# BOND

Service Bulletin

BOND BUG (ALL MODELS)

## BRAKING SYSTEM

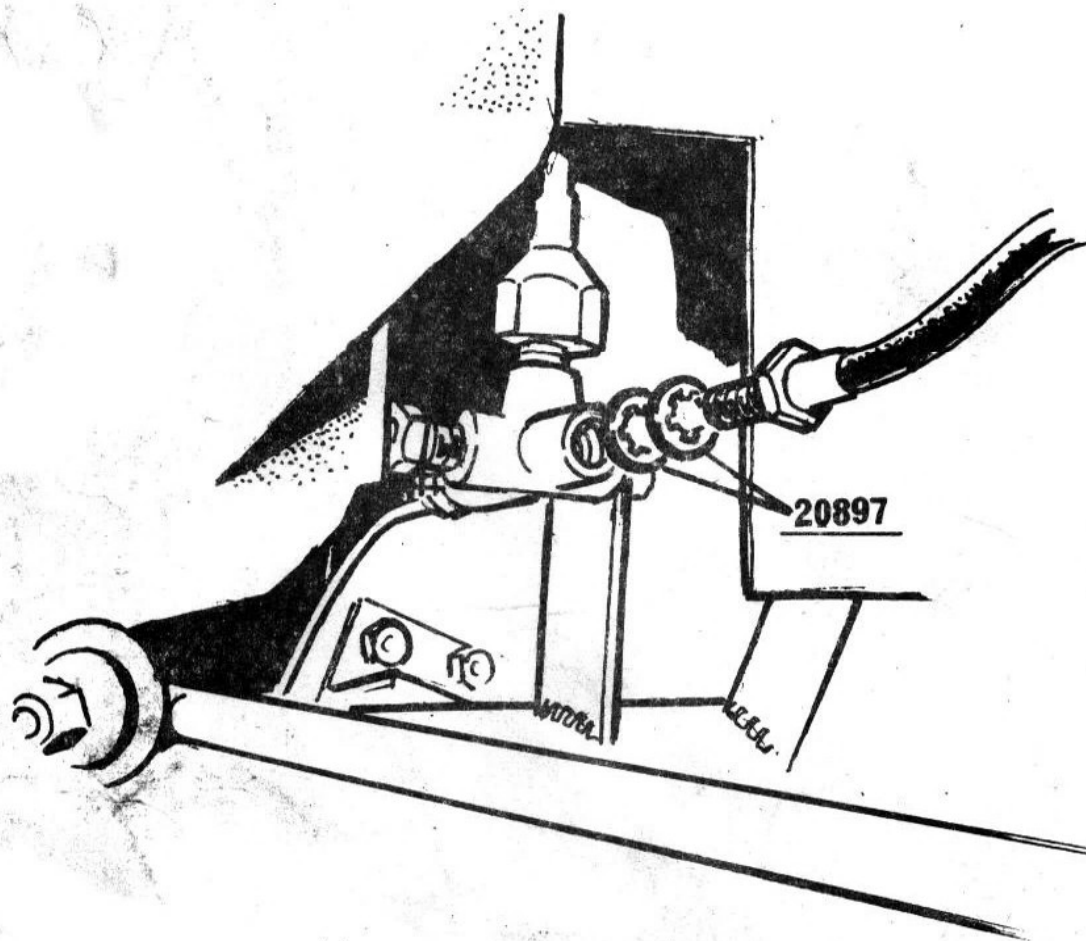
To improve sealing of the front flexible hose to the 3 way, situated on the front suspension crossmember, a second gasket, Part Number 20897, has now been added in production.

All existing vehicle stocks up to Chassis Number 60261 must be checked for leakage and the additional gasket fitted.

FIGURE 1.  
Canopy Hinge from under  
front of body

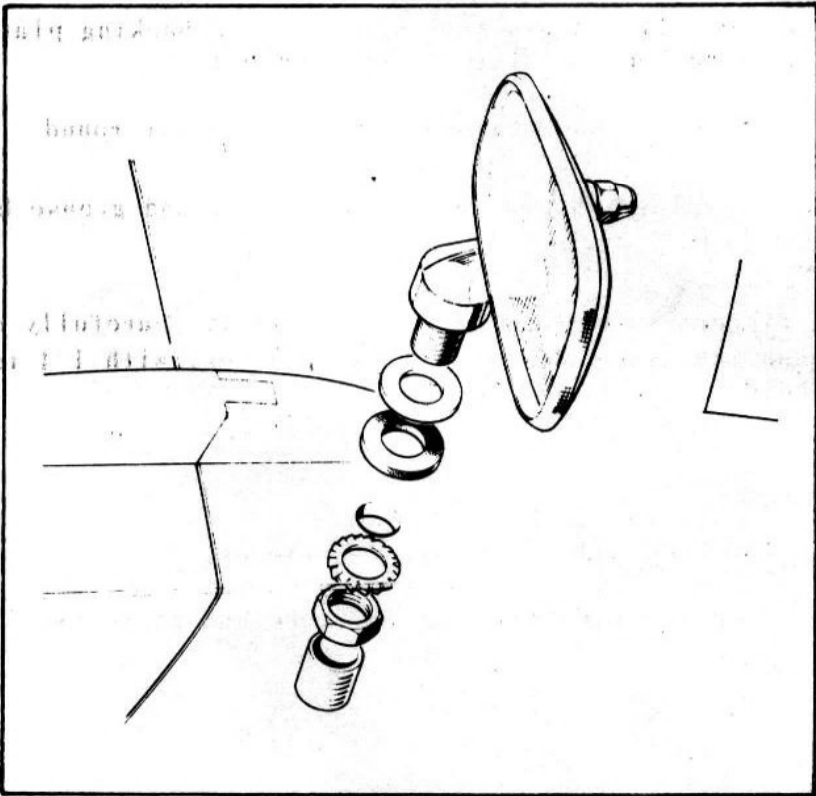
We have received reports of the fibreglass body cracking or distorting around the canopy hinges, where they are attached to the scuttle.

Dealers are requested to examine vehicle for evidence of this and rectify by fitting an additional hinge backing plate, part No.209910, as follows:-

1. Remove the four set screws, hexagon nuts, lockwashers and plain washers securing the canopy hinges to the body.
2. Remove hexagon shoulder bolt and spacing washers securing the pneumatic support to the bracket on the console.
3. Disconnect the windscreen wiper motor leads at the snap connectors and the washer water tube at the non-return valve.
4. Lift the canopy from the vehicle.
5. Remove wing mirror if fitted.
6. Using one layer of 1.4 oz. fibreglass matting, bond the backing plate to the scuttle, over the existing backing plate. See Figure 1.

The matting should overlap the backing plate 1.5 inches all round.
